ATTACHMENT C-1

MARKED UP PAGES FOR
PROPOSED CHANGES TO APPENDIX A
TECHNICAL SPECIFICATIONS OF
FACILITY OPERATING LICENSES
NPF-72, AND NPF-77

BRAIDWOOD STATION UNITS 1 & 2
REVISED PAGES:

FIGURE 3.4-1

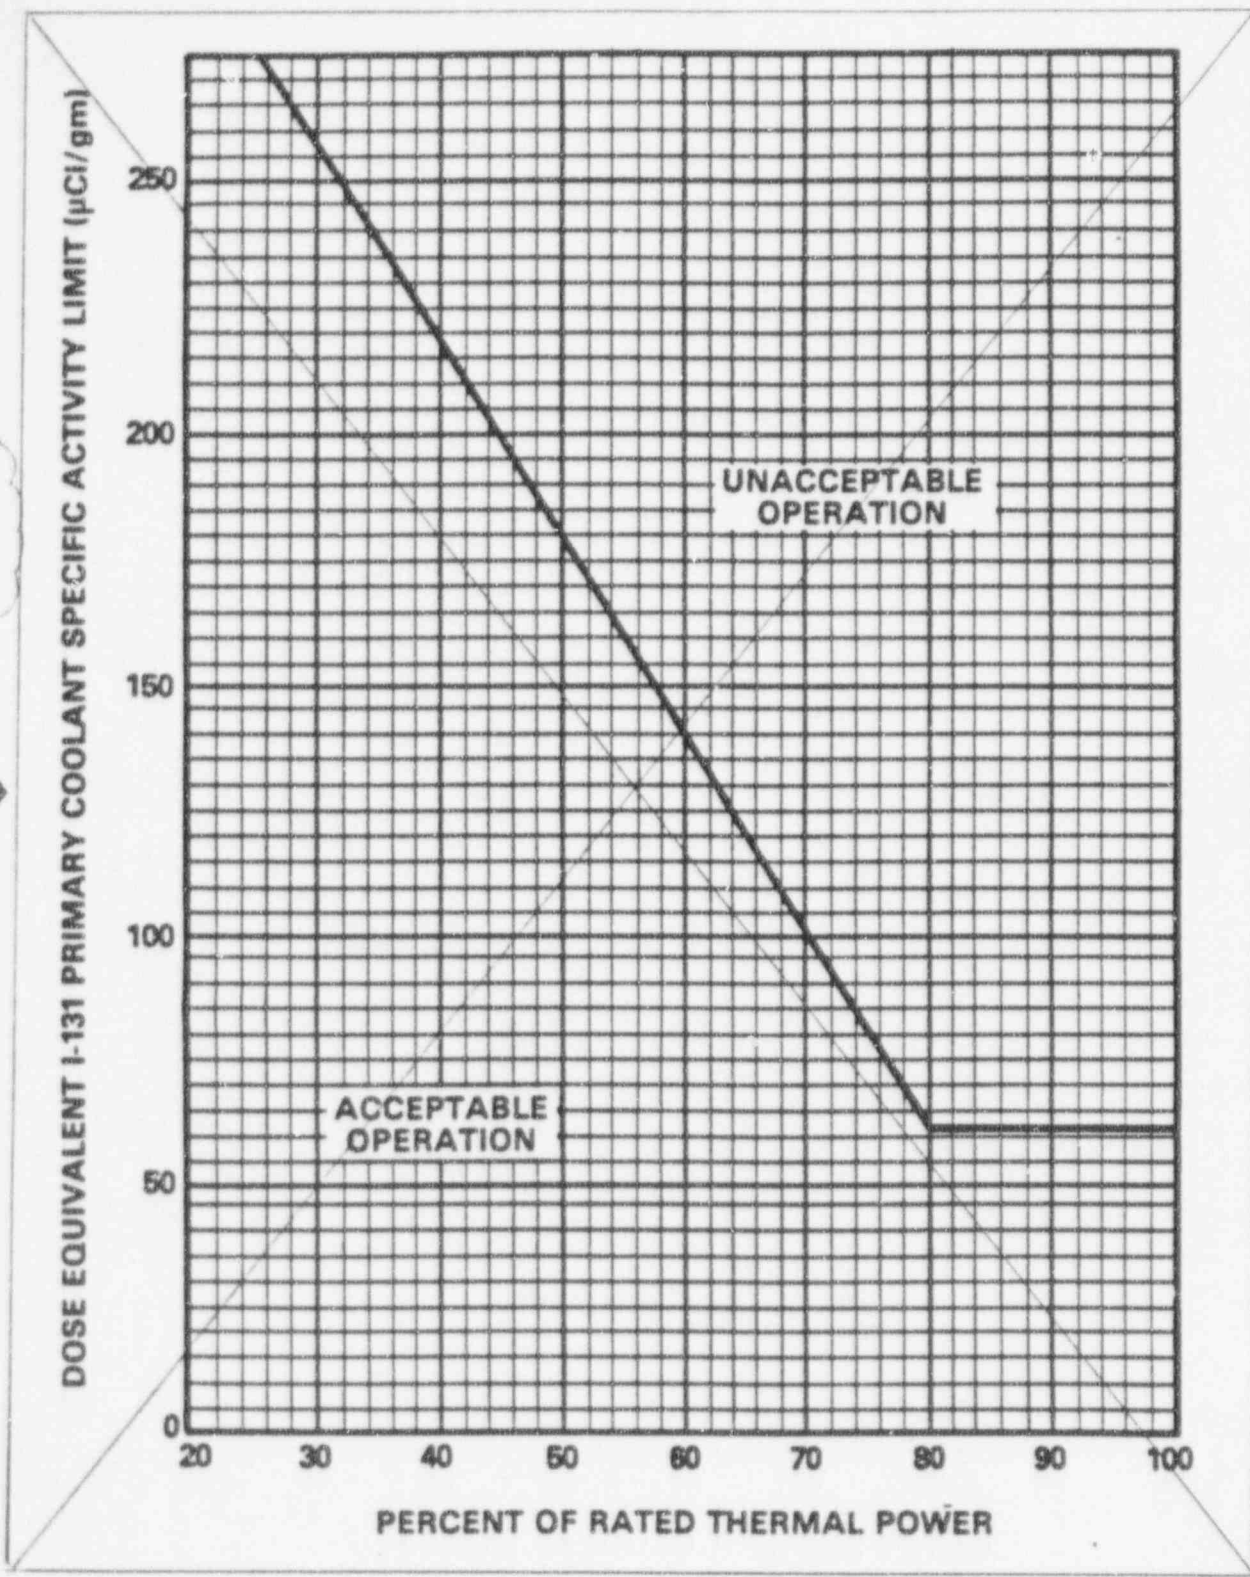
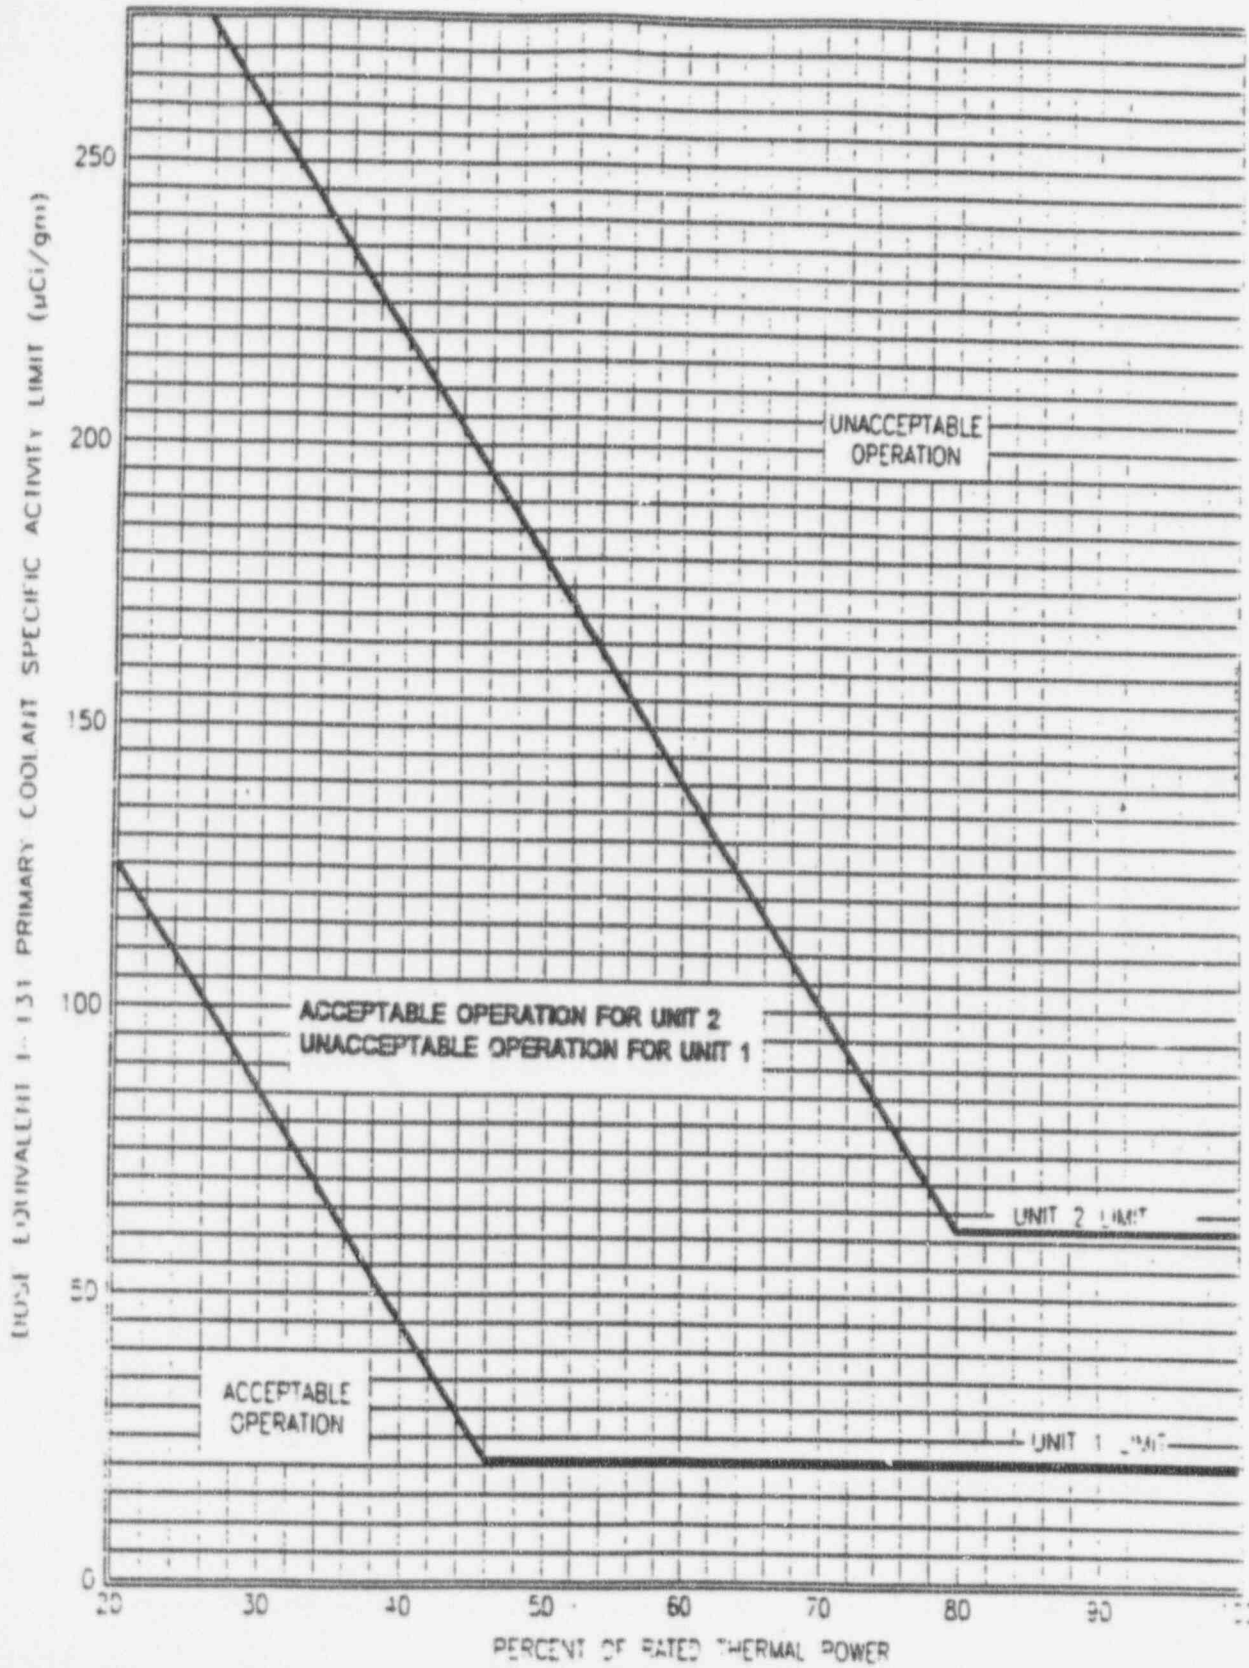
Replace with Inert F

* For Unit 1, Reactor Coolant Specific Activity > 0.35 µCi/Gram Dose Equivalent I-131

INSERT F

(Figure 3.4-1)

Figure 3.4-1 Dose Equivalent I-131 Reactor Coolant Specific Activity Limit Versus Percent of Rated Thermal Power with the Reactor Coolant Specific Activity $> 1\mu\text{Ci}/\text{Gram}$ Dose Equivalent I-131*

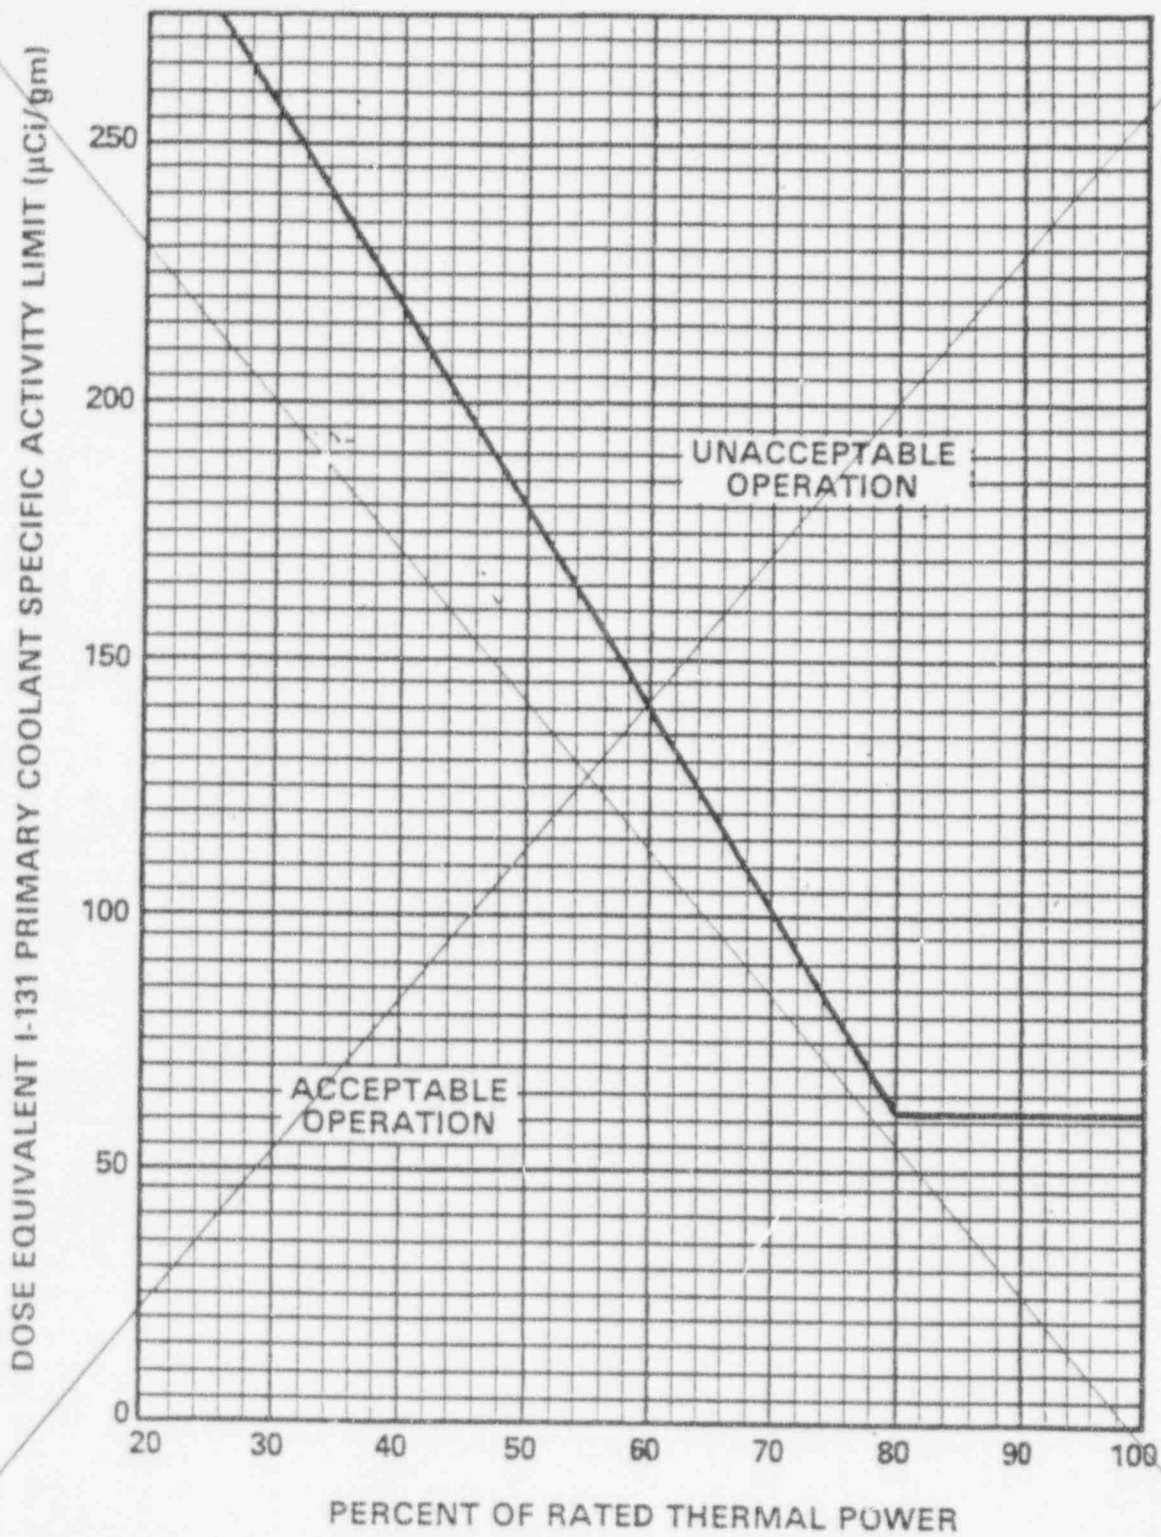
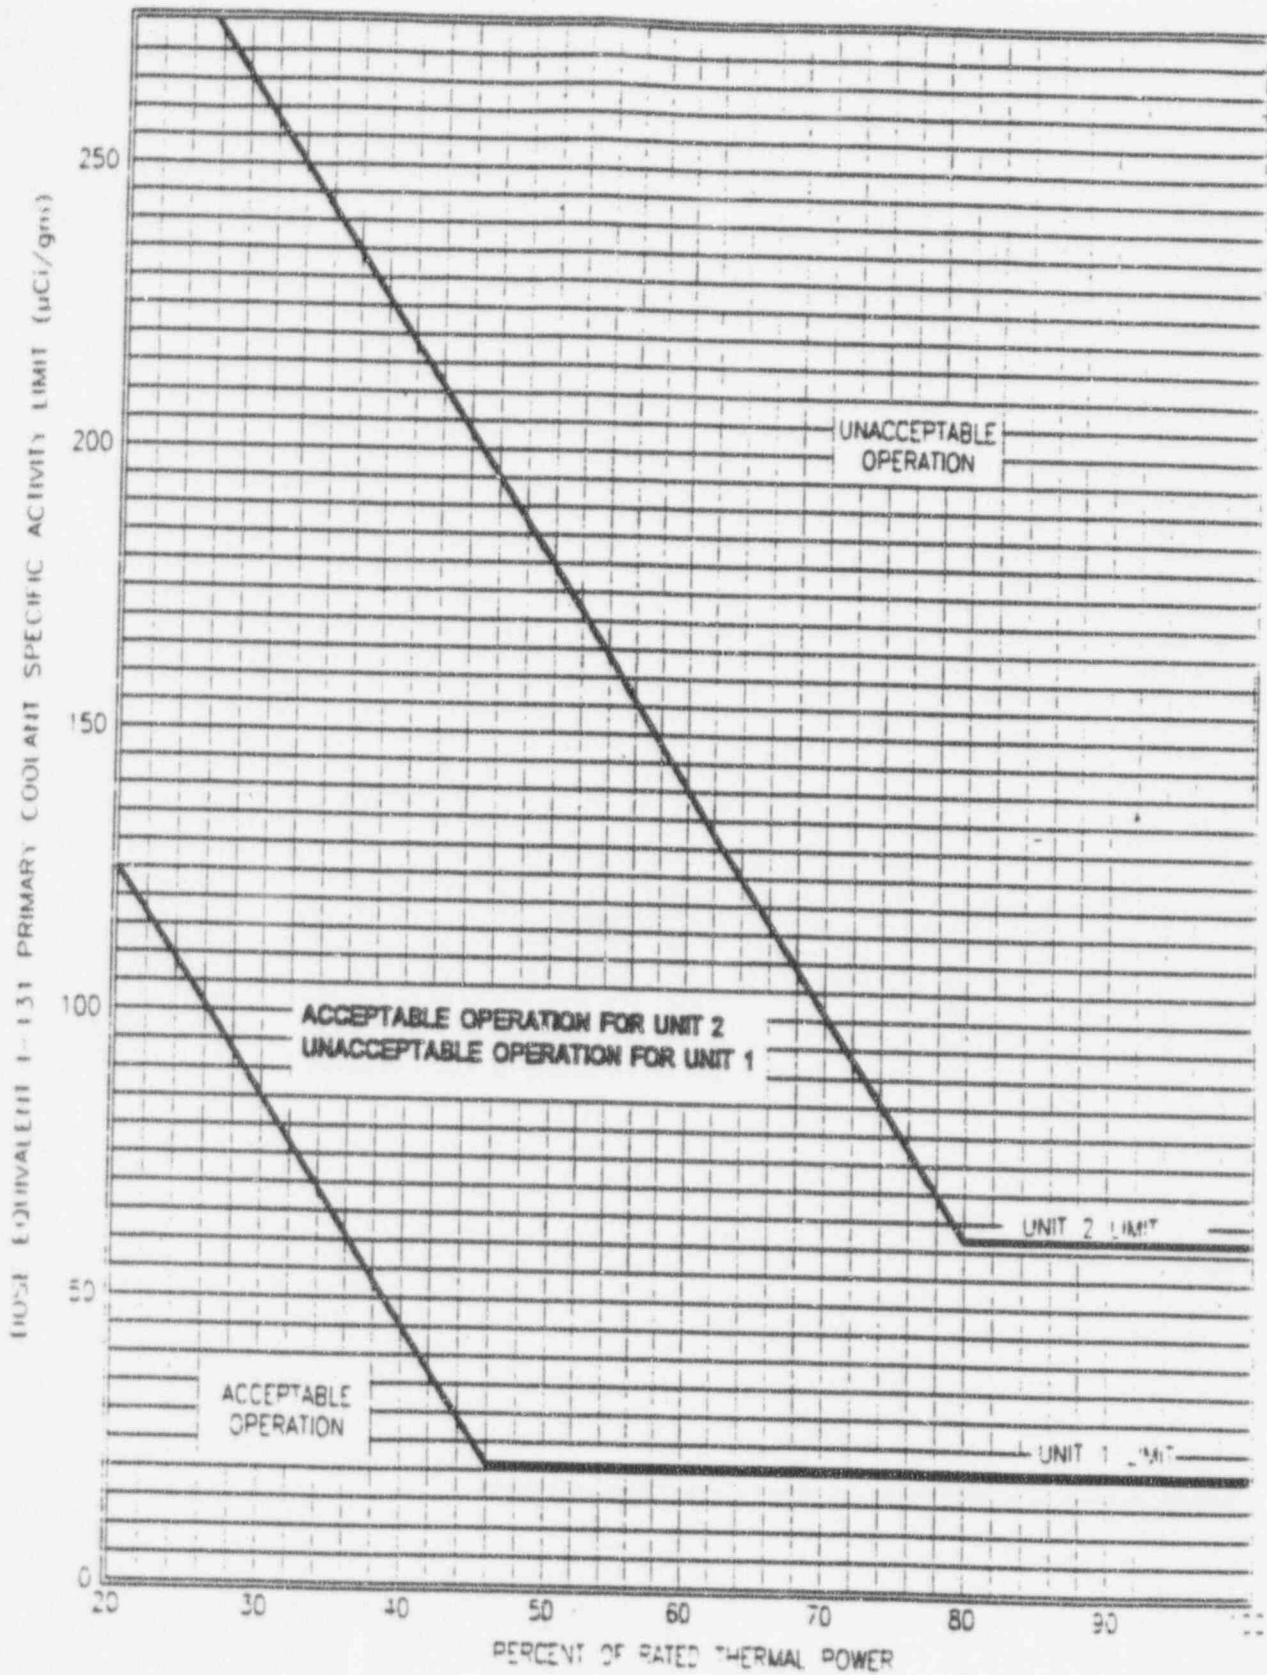
Replace with insert F

* For Unit 1, Reactor Coolant Specific Activity $0.35 \mu\text{Ci}/\text{Gram}$ Dose Equivalent I-131

INSERT F

(Figure 3.4-1)
